BEFORE THE ATOMIC SAFETY AND LICENSING BOARD

DOCKET NO. 50-332-OL

DEPOSITION OF MAURICE H. LOWREY

ABS Check Cales

Figure 3-1. Goodman diagram for replacement crankshafts.

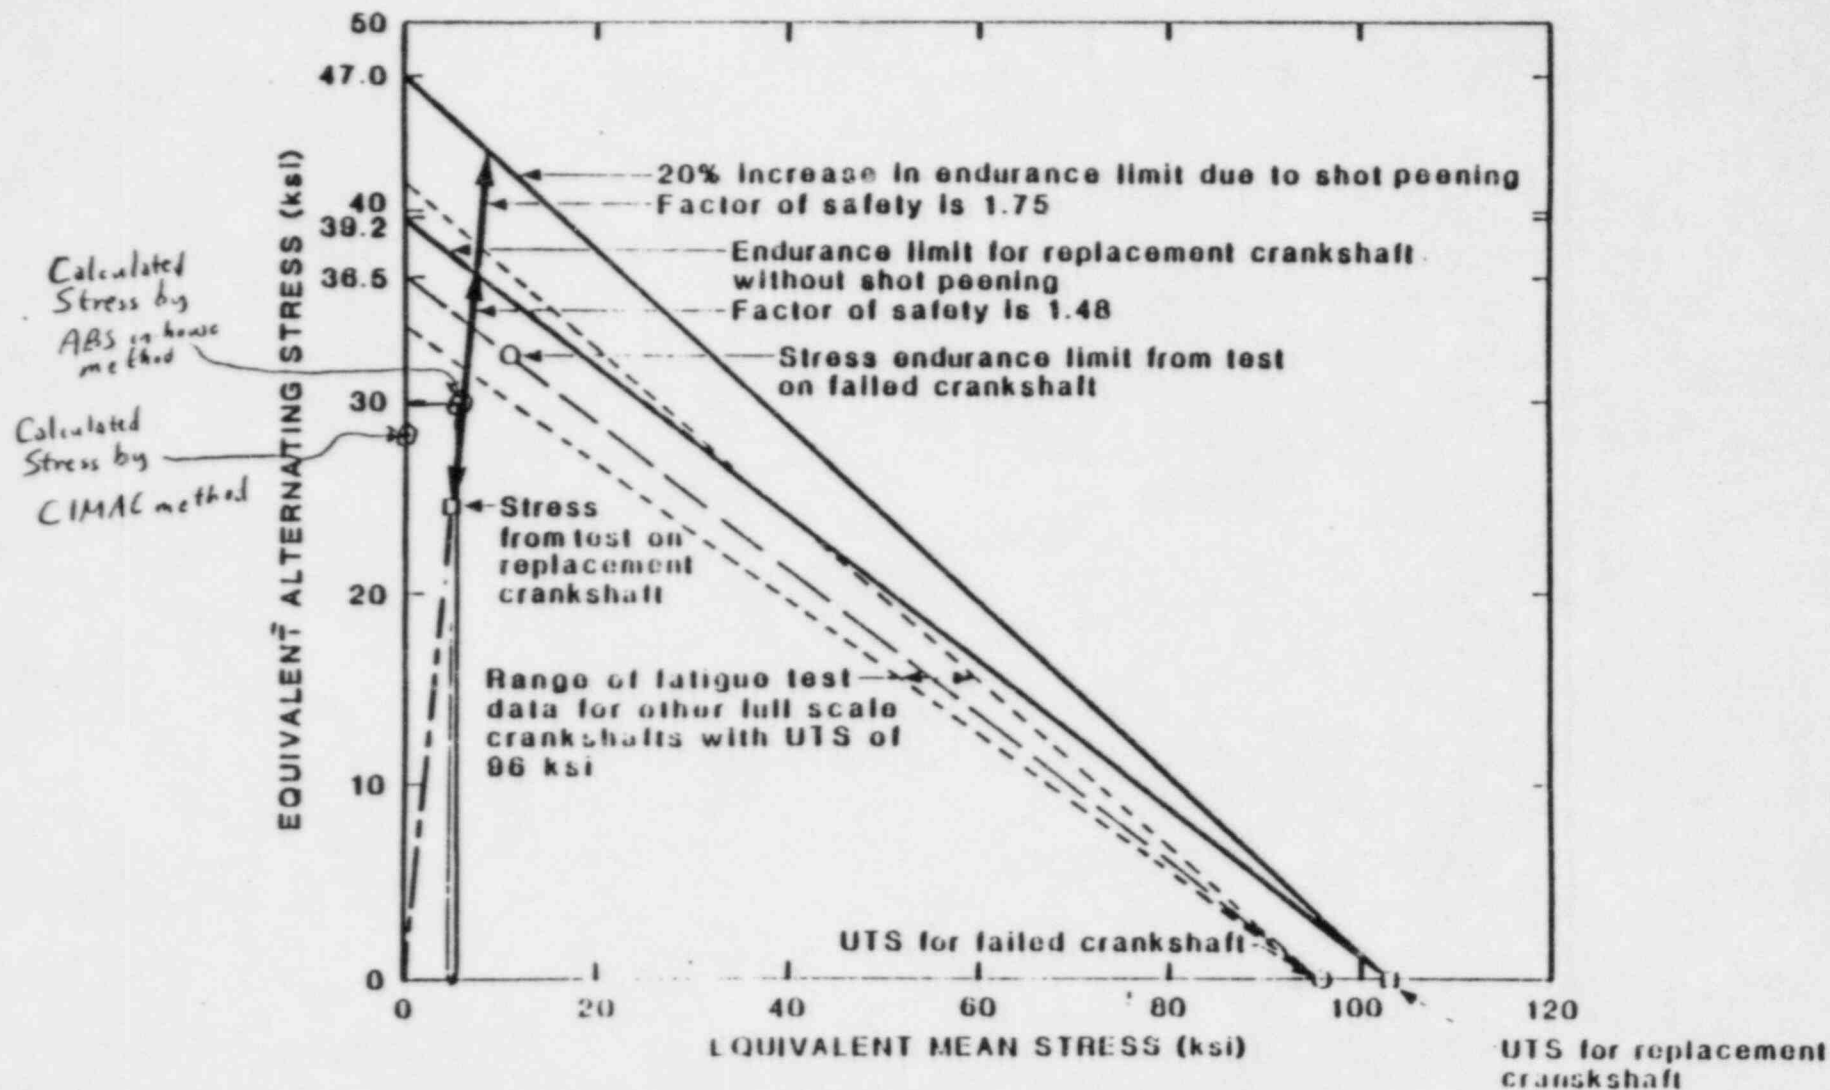
Safety Factors - desired minimum = 1.34 - lowest
for spec
review of
another
mfg.

Combined S.F. - Goodman method ($\frac{1}{SF} = \frac{1}{SF_{steady}} + \frac{1}{SF_{alt}}$)

(theoretical)
For CIMAC fatigue limit \rightarrow 1.044 (LOW)

For submitted F.L. - no shot peen \rightarrow 1.224 (LOW/MARGINAL)

For submitted F.L. - w/shot ~~peening~~ \rightarrow 1.450 (OK)

Combined S.F. - Elliptical method ($\frac{1}{SF^2} = \frac{1}{SF_{alt}^2} + \frac{1}{SF_{st}^2}$)

(theoretical)
For CIMAC fatigue limit \rightarrow 1.103 (LOW)

For submitted F.L. - no shot peen \rightarrow 1.306 (OK) (but marginal)

For submitted F.L. - shot peened \rightarrow 1.565 (OK)

Conclusions

- 1) Based on submitted fatigue strength data and test results, proposed torsional vibration arrangements are OK.
- 2) Note that submitted fatigue strength is higher than that obtained by CIMAC formula.
- 3) Note also that submitted stress^{test} results show ~~the~~ lower stresses than those calculated by either CIMAC or ABS formulas
